HISTORIC AND DESIGN REVIEW COMMISSION

HDRC CASE NO: 2019-388
ADDRESS: 314 W ELSMERE PLACE
LEGAL DESCRIPTION: NCB 3967 BLK 2 LOT 7&8
ZONING: R-5, H
CITY COUNCIL DIST.: 1
DISTRICT: Monte Vista Historic District
APPLICANT: Pam Carpenter/Seventh Generation Design, Inc.
OWNER: Clay & Kimberly Cauthorn/CAUTHORN KIMBERLY KLEIN & VIRGIL CLAY
TYPE OF WORK: Construction of an addition to an existing accessory structure
APPLICATION RECEIVED: June 28, 2019
60-DAY REVIEW: August 27, 2019
CASE MANAGER: Edward Hall
REQUEST:

**Historic and Design Review Commission
Design Review Committee
Report & Recommendation**

2 PROPOSED SITE PLAN
1" = 10'-0"

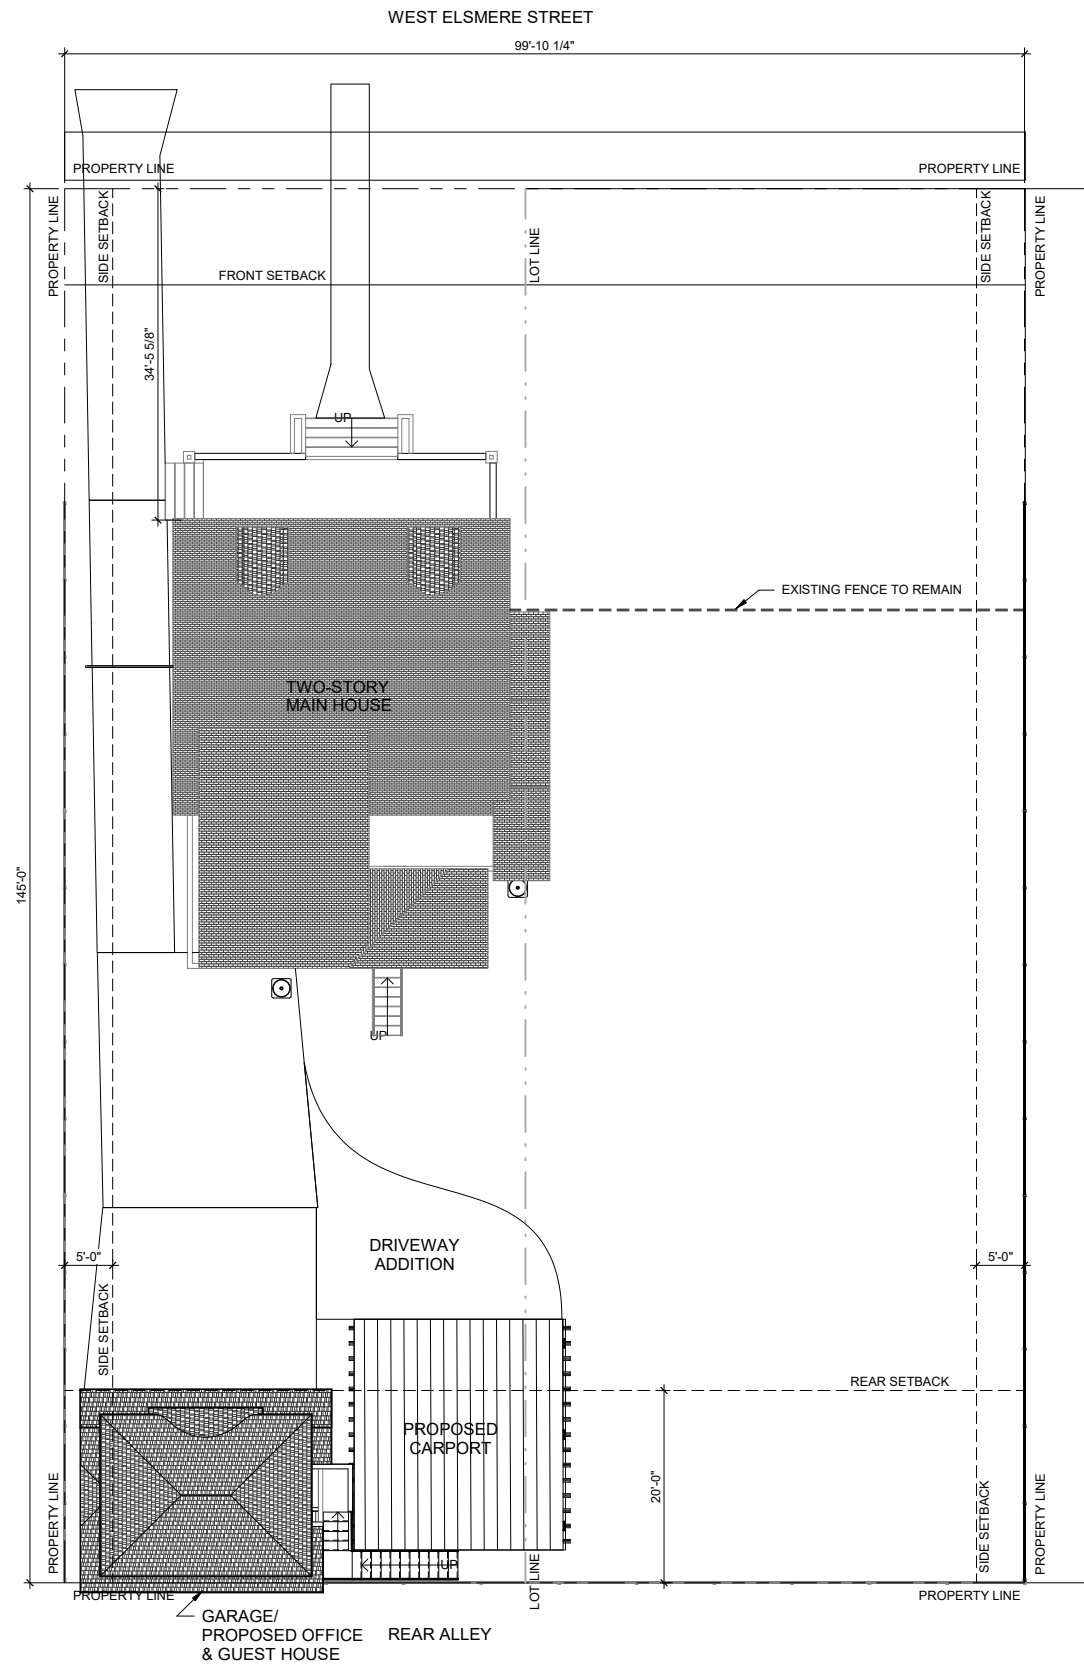
- d. CARPORT – On the rear (southern) property line, the applicant has proposed to construct a carport to feature parking for two automobiles. The proposed carport is to feature an overall footprint of 528 square feet and an overall height of approximately twelve (12) feet in height.

- e. SETBACKS & ORIENTATION – The Guidelines for New Construction 5.B. state that the predominant garage orientation found along the block should be matched. Additionally, historic setback patterns of similar structures should be followed. The applicant has proposed to locate the carport on the rear (southern) property line. This location is consistent with the historic examples found both on this property and throughout the Monte Vista Historic District; however, the applicant is responsible for acquiring any variances from the Board of Adjustment in regards to rear setback regulations.

- m. SITE WORK – The applicant has proposed site work to include improvements to the existing driveway in the vicinity of the garage and proposed carport for vehicular maneuvering, draining and landscaping. Staff finds the proposed site work to be appropriate.

1. Staff recommends conceptual approval of item #1, the construction of a carport with the following stipulations:
 - i. That the proposed standing seam metal roof feature panels that are 18 to 21 inches wide, seams that are 1 to 2 inches in height, a crimped ridge seam and a standard galvalume finish.

OPTION 4.2 FIRST & SECOND FLOOR PLANS

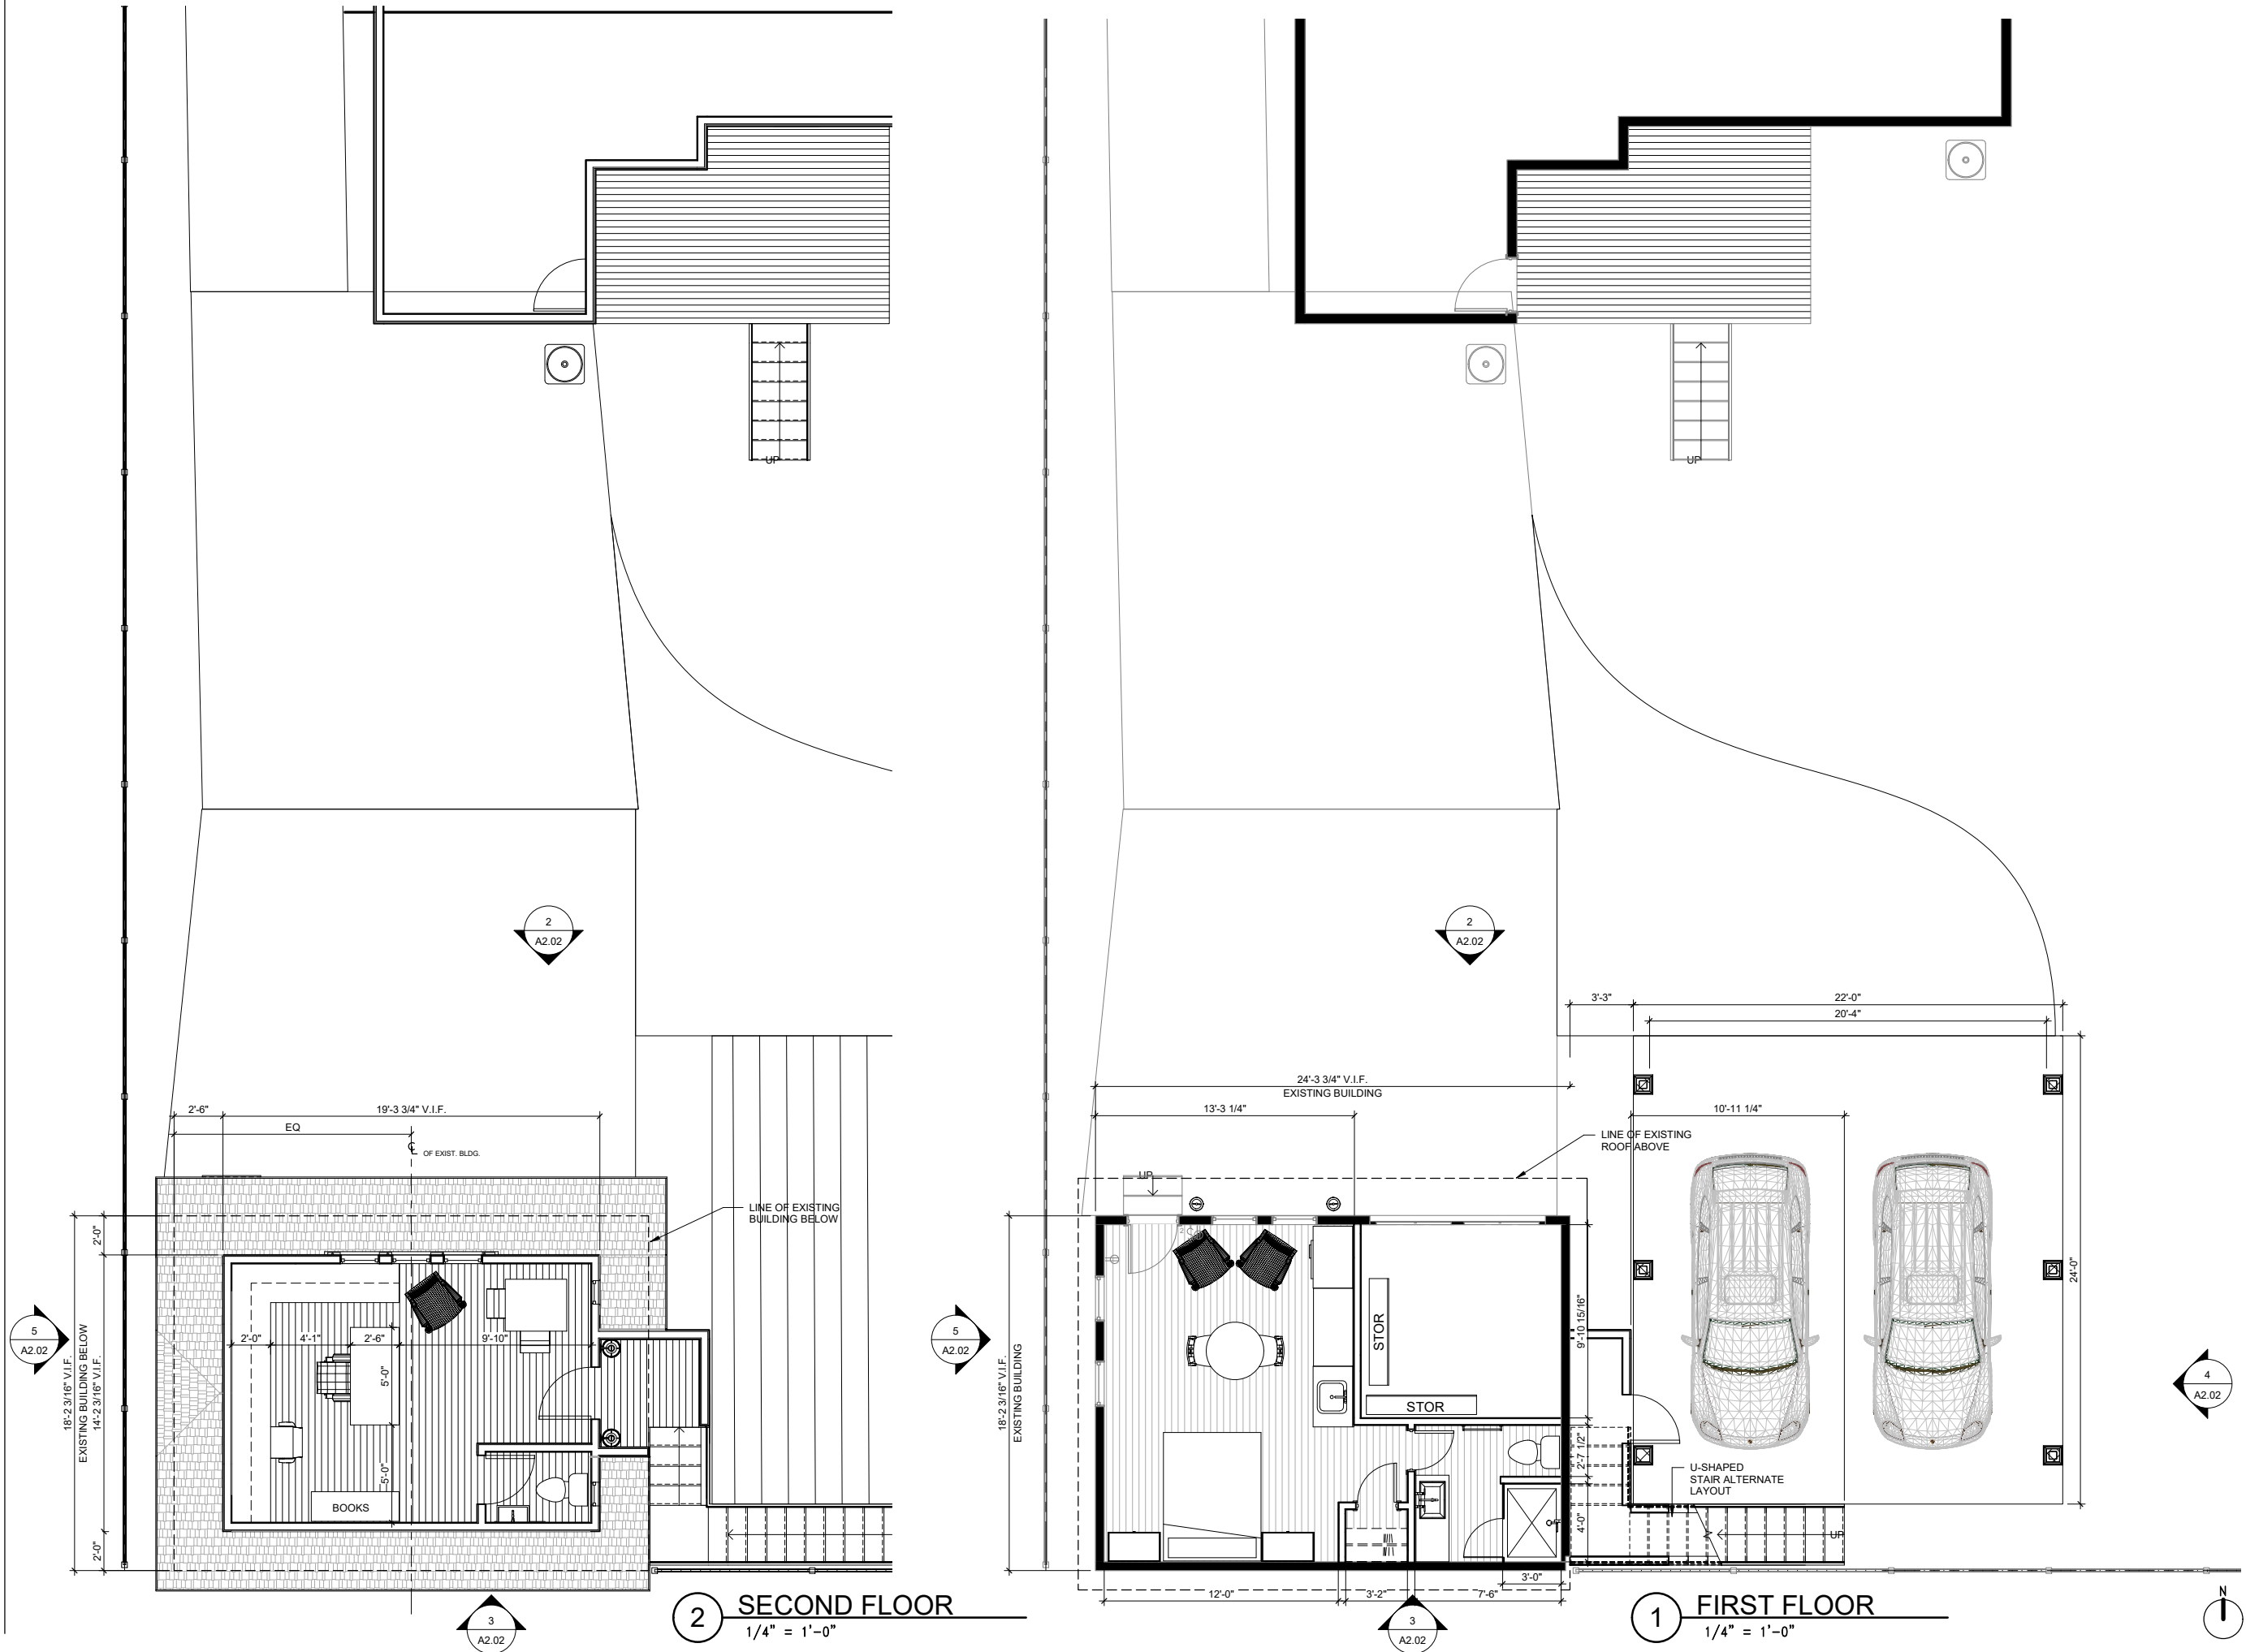
- i. GARAGE ADDITION – The applicant has proposed to construct a second story addition on top of the existing, rear garage. The Guidelines for Additions 1.A. states that additions should be sited to minimize visual impact from the public right of way, should be designed to be in keeping with the historic context of the block, should utilize a similar roof form and should feature a transition between the old and the new. Additionally, the Guidelines for Additions 1.B. notes that rooftop additions should be limited to rear facades to preserve the historic scale and form of the building from the street level, and to minimize visibility from the public right of way. Given that the proposed addition is to a rear accessory structure, staff finds the proposed second story addition to be appropriate; however, staff finds that the applicant should submit a line of sight study to confirm that the proposed accessory structure's increased height will not be visible from the right of way on W Elsmere.

- j. ARCHITECTURAL DETAILS (Addition) – The applicant has proposed a number of architectural details for the proposed addition that are generally in keeping with the Guidelines, and complement the architecture of the historic primary historic structure. The structure currently features a clipped gable roof. The applicant has proposed a hipped roof with an eyebrow shed feature that faces toward the front of the property.

- i. That the applicant should submit a line of sign study to confirm that the proposed accessory structure’s increased height will not be visible from the right of way on W Elsmere.

OPTION 4.2 CONCEPTUAL VIEWS

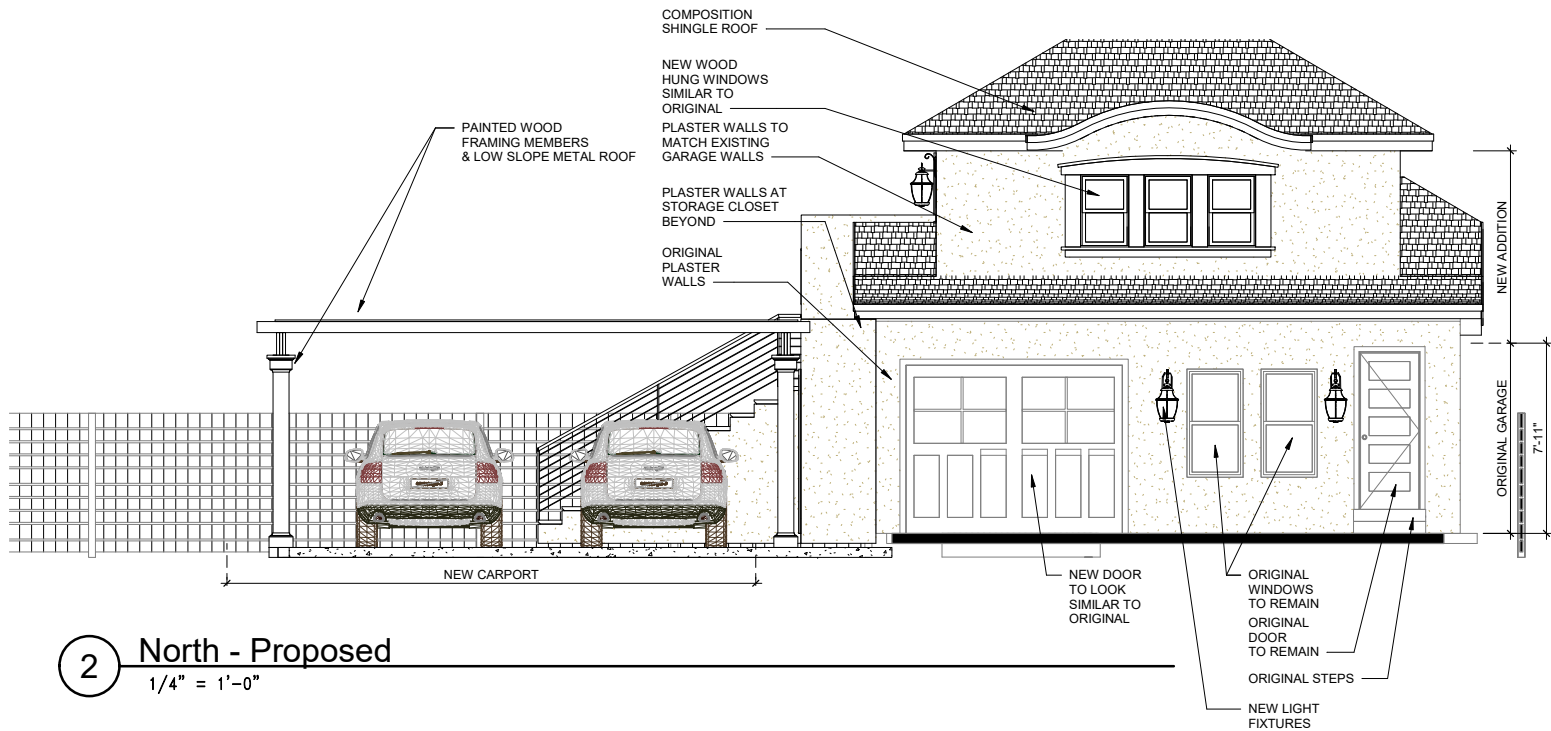
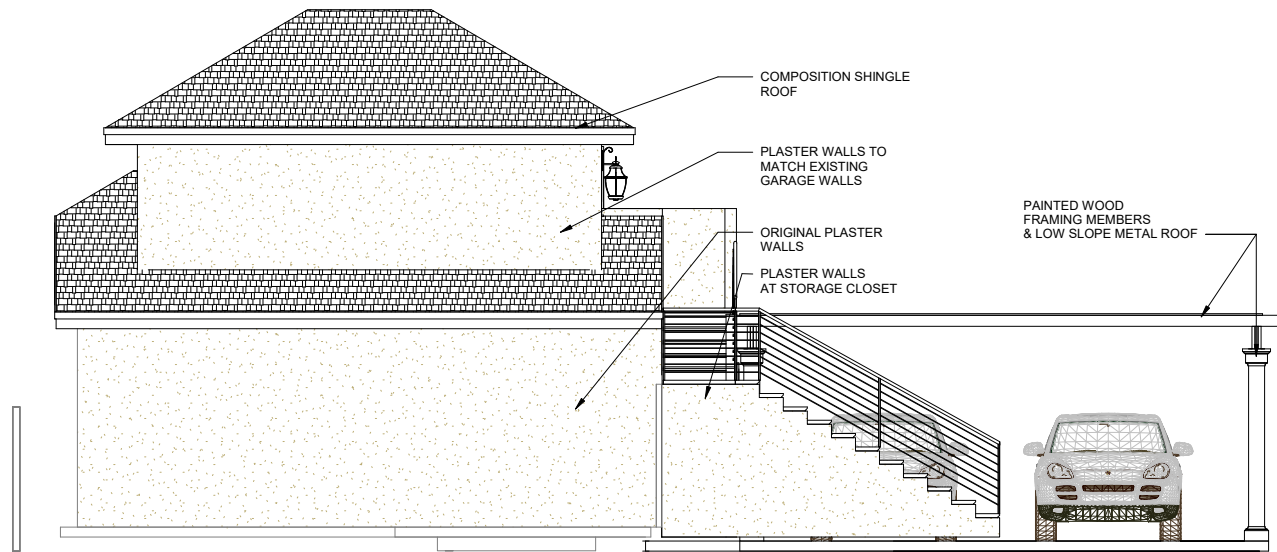
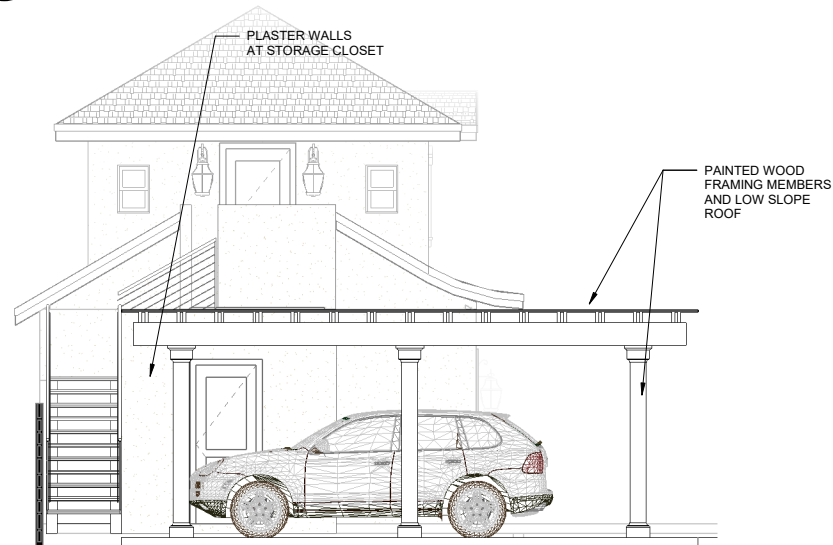
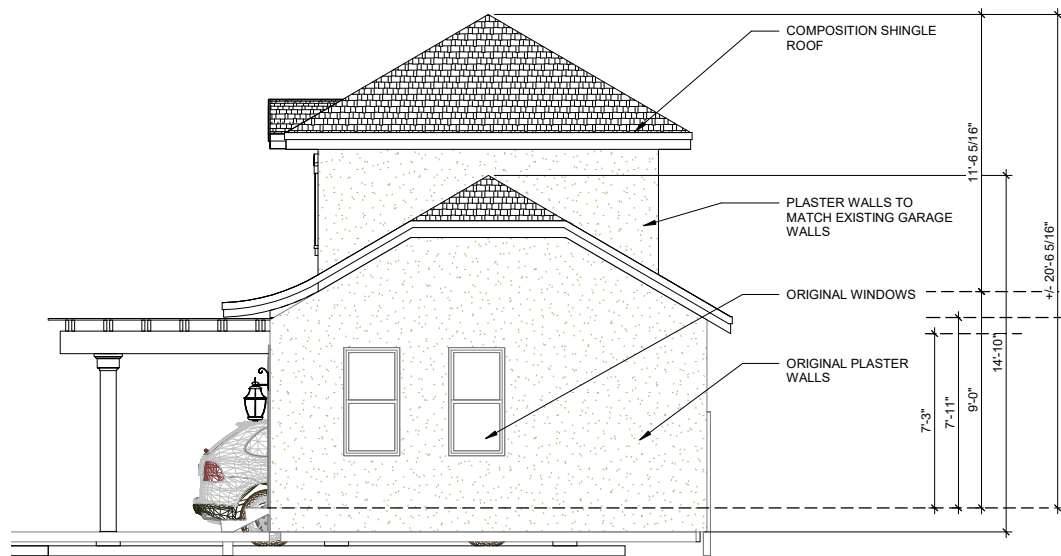
- g. CHARACTER – The Guidelines for New Construction 5.A.iii. notes that new garages and outbuildings should relate to the period of construction of the primary historic structure on the lot through the use of complementary materials and simplified architectural details. The applicant has proposed a flat roof, painted wood members, a low sloped metal roof, as well as Craftsman details including columns and rafter tails. Generally, staff finds the proposed character and architectural details to be appropriate and consistent with the Guidelines. The proposed standing seam metal roof should feature panels that are 18 – 21 inches wide, seams that are 1 to 2 inches in height, a crimped ridge seam and a standard galvalume finish.

- k. MATERIALS – The applicant has proposed materials that include a plaster walls, wood windows and a

composition shingle roof. Generally, staff finds the proposed materials to be appropriate. When returning for final approval, the applicant should provide specifications for all materials.

- l. WINDOW MATERIALS – As noted in finding k, the applicant has proposed to install wood windows. Staff finds the proposed materials to be appropriate. Meeting rails must be no taller than 1.25” and stiles no wider than 2.25”. White manufacturer’s color is not allowed, and color selection must be presented to staff. There should be a minimum of two inches in depth between the front face of the window trim and the front face of the top window sash. This must be accomplished by recessing the window sufficiently within the opening or with the installation of additional window trim to add thickness. Window trim must feature traditional dimensions and architecturally appropriate sill detail. Window track components must be painted to match the window trim or concealed by a wood window screen set within the opening.

- ii. That the proposed windows feature meeting rails must be no taller than 1.25” and stiles no wider than 2.25”. White manufacturer’s color is not allowed, and color selection must be presented to staff. There should be a minimum of two inches in depth between the front face of the window trim and the front face of the top window sash. This must be accomplished by recessing the window sufficiently within the opening or with the installation of additional window trim to add thickness. Window trim must feature traditional dimensions and architecturally appropriate sill detail. Window track components must be painted to match the window trim or concealed by a wood window screen set within the opening.

- iii. That the proposed plaster match that of the historic structure.
3. Staff recommends conceptual approval of item #3 as submitted.
